NO: PMS-007 PRODUCT: EE-SX1096-W1 Photomicrosensor

DATE: March 2016 TYPE: Discontinuation Notice

EE-SX1096-W1 Photomicrosensors to be DISCONTINUED

Dimensions:

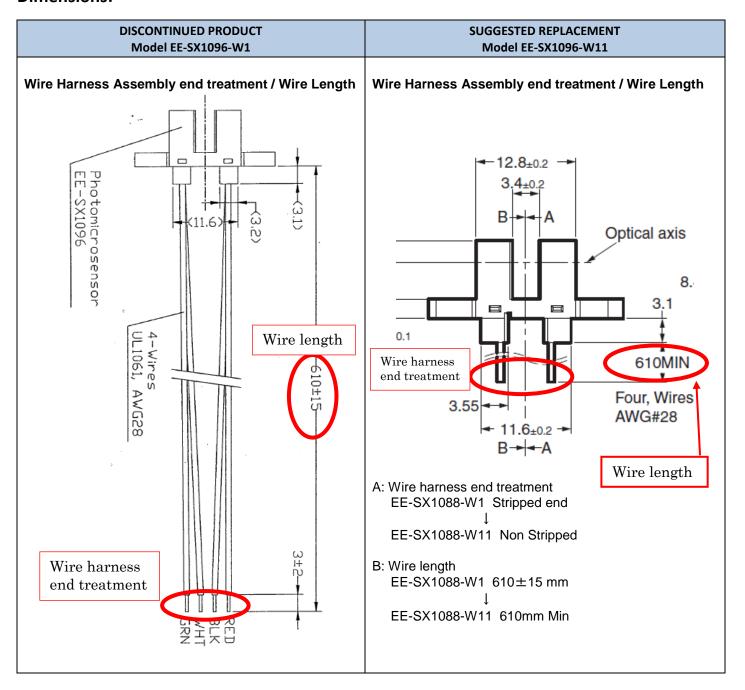
Details of differences between W1 and W11 wire assembly:

Any differences between the part are minimal and <u>only</u> relate to the wire harness assembly. The details are as follows:

- Wire harness assembly end treatment:
 - W1 version: Stripped ends.
 - W11 version: No Stripped ends.
- Length of wire harness assembly:
 - W1 version: Wire Length = 610mm +/- 15mm.
 - W11 version: Wire Length = 610mm MIN. 645mm MAX.
- Country of origin:
 - o W1 version: Cable Assembly in U.S.A
 - o W11 version: Cable Assembly in Japan

Model EE-SX1096-W11
